PROJECT: GRK Corporate Hangar Phase II
AIP # 3-48-0361-050-2022

Change Order No. 003 makes the following changes, see attached for detailed terms of the change order.

Project:
GRK Corporate Hangar Phase II City of Killeen Bid No. 23-06
Killeen-Fort Hood Regional Airpc FAA AIP No. 3-48-0361-050-2022
Garver Project No. 21A06081

Change Order No. 3

ENLARGED GRADING PLAN II

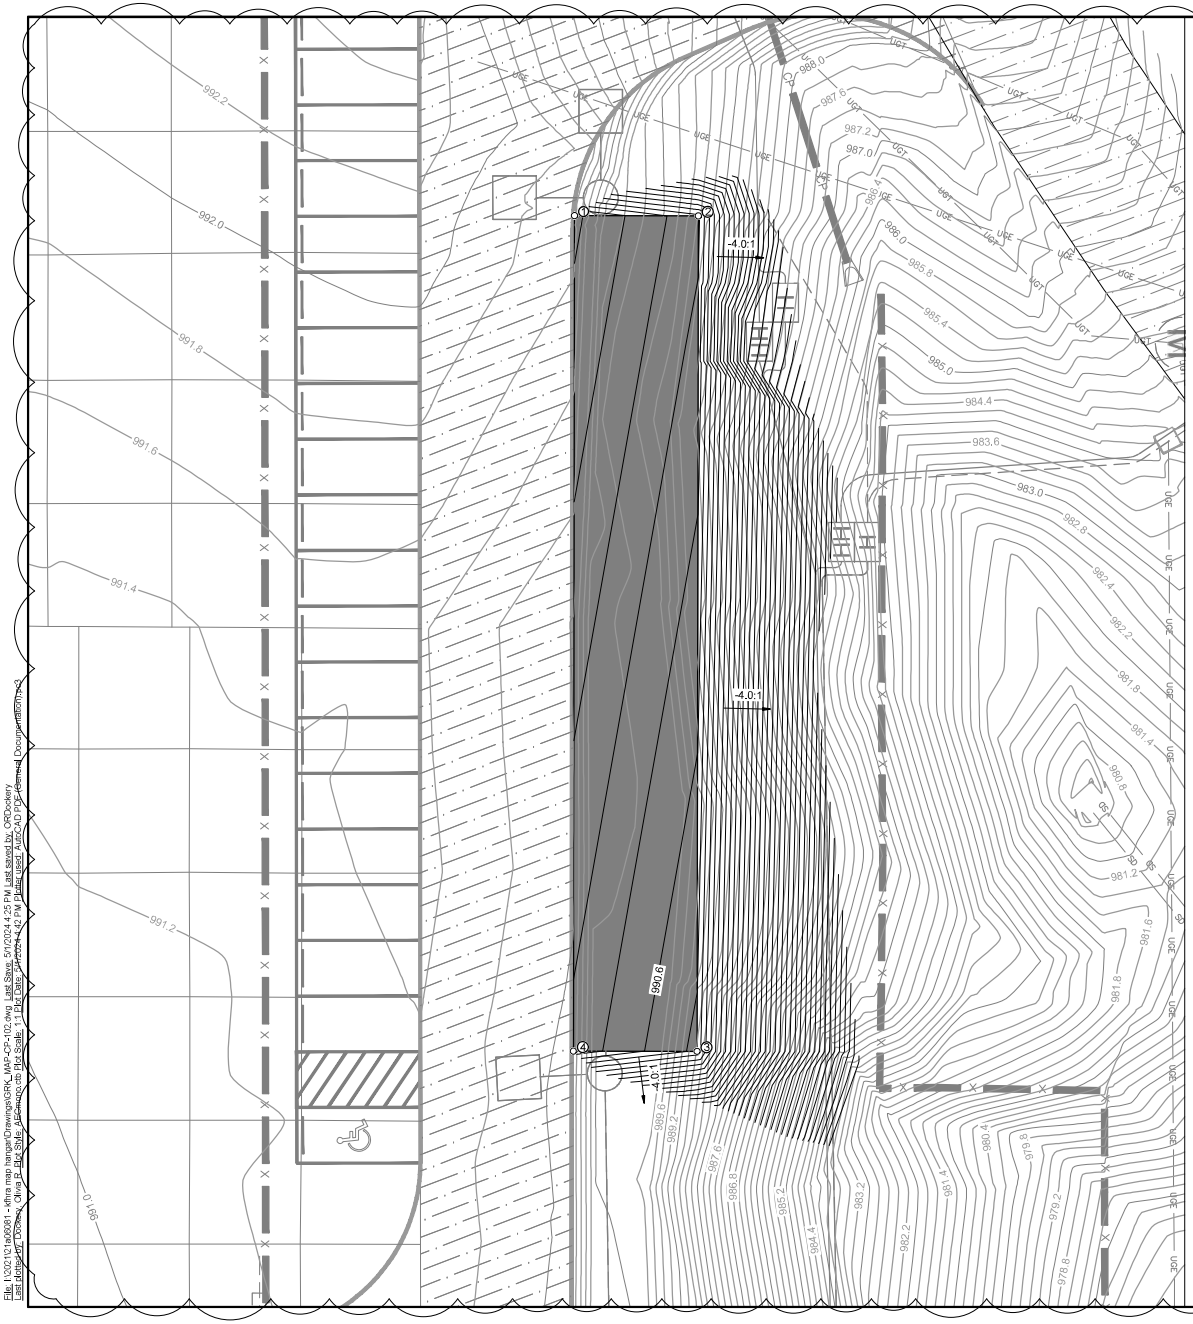
A. Change includes increasing parking area necessary to support the functions of the building based on Owner input. Contractor shall construct the additional parking area per the attached Drawings. Note, engineer may provide contractor with revised and finalized design sheets. Contractor shall notify engineer a minimum of 4 weeks prior to affected work to allow engineer a minimum of 2 weeks to provide finalized drawings ahead of Contractor layout/staking.

REV.	DATE	DESCRIPTION	BY
-	2/24/23	ISSUED FOR CONSTRUCTION	JCG
1	5/6/24	C.1.0.3 - ADDITIONAL PARKING	JCG

JOINT LAYOUT PLAN

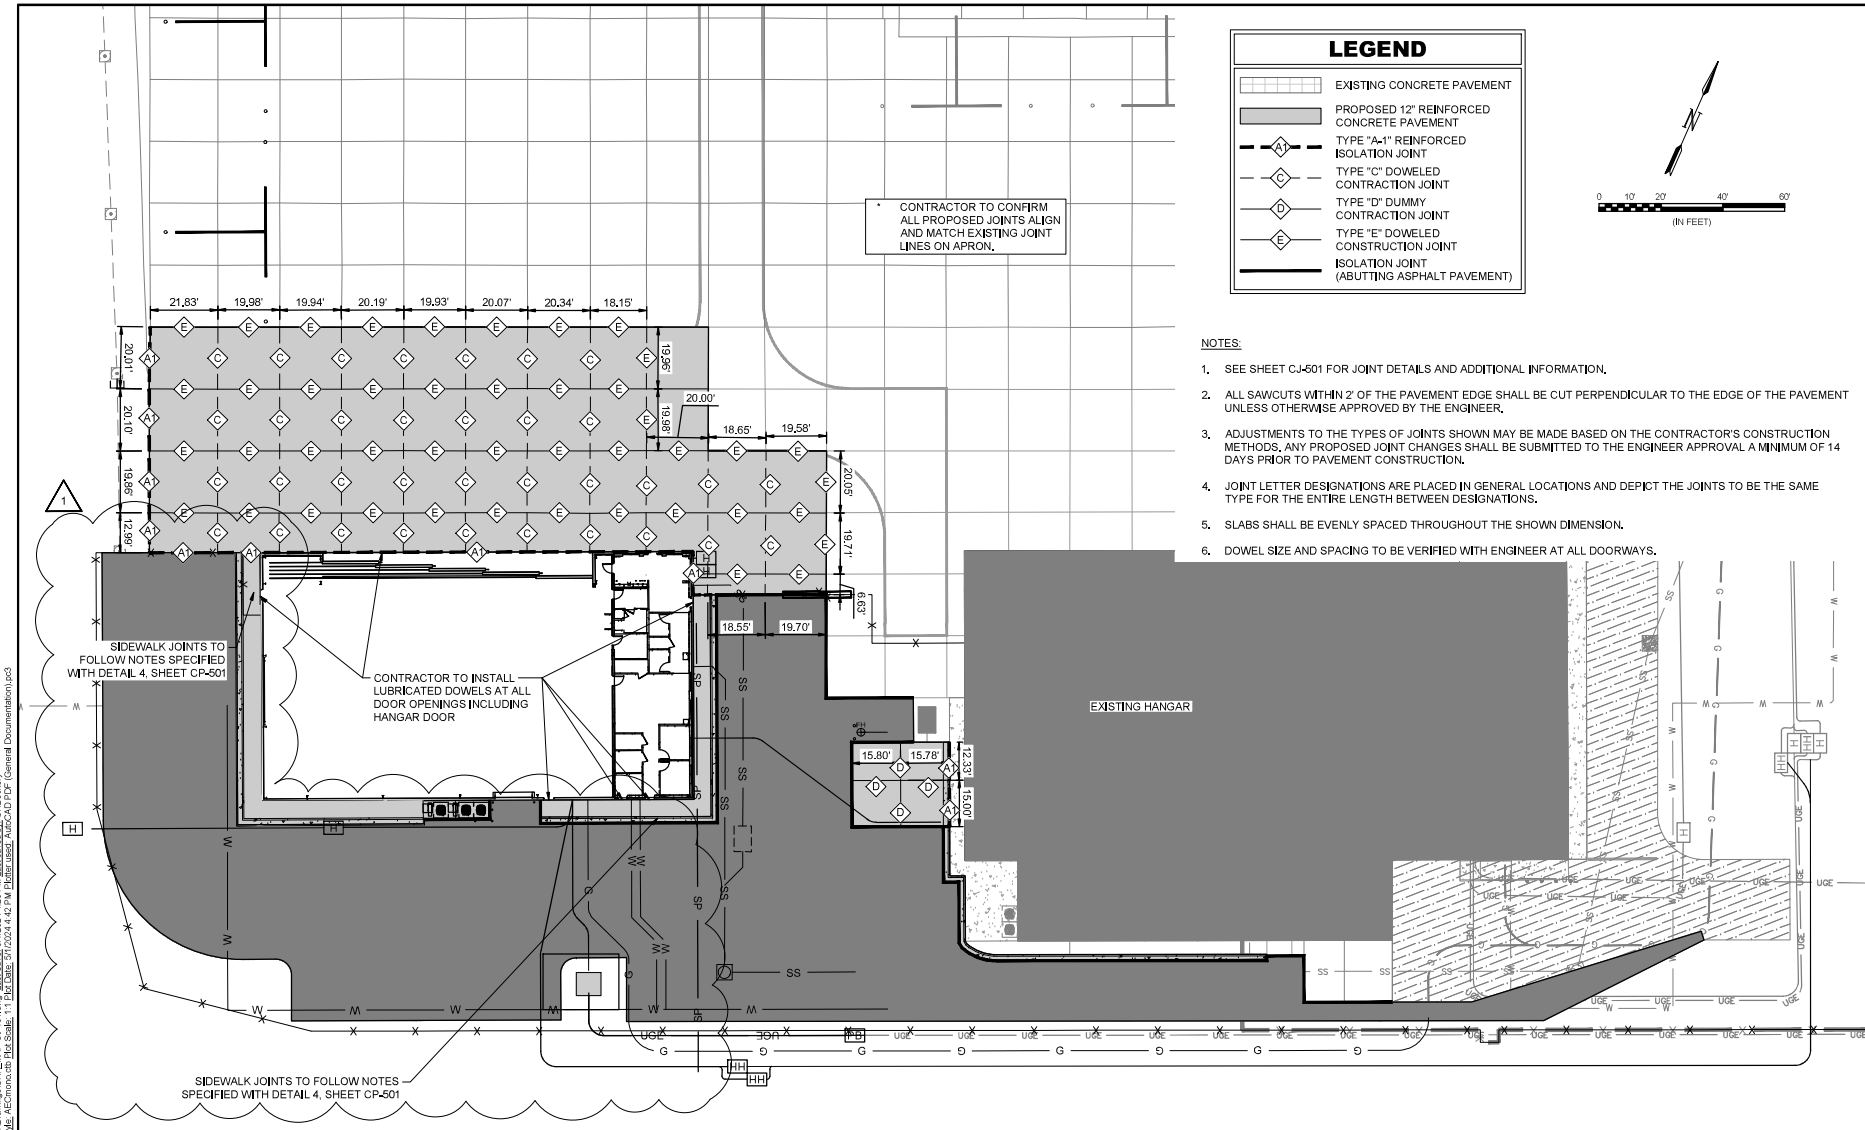
REV.	DATE	DESCRIPTION	BY
-	2/24/23	ISSUED FOR CONSTRUCTION	JCG
1	5/6/24	C.1.0.3 - ADDITIONAL PARKING	JCG
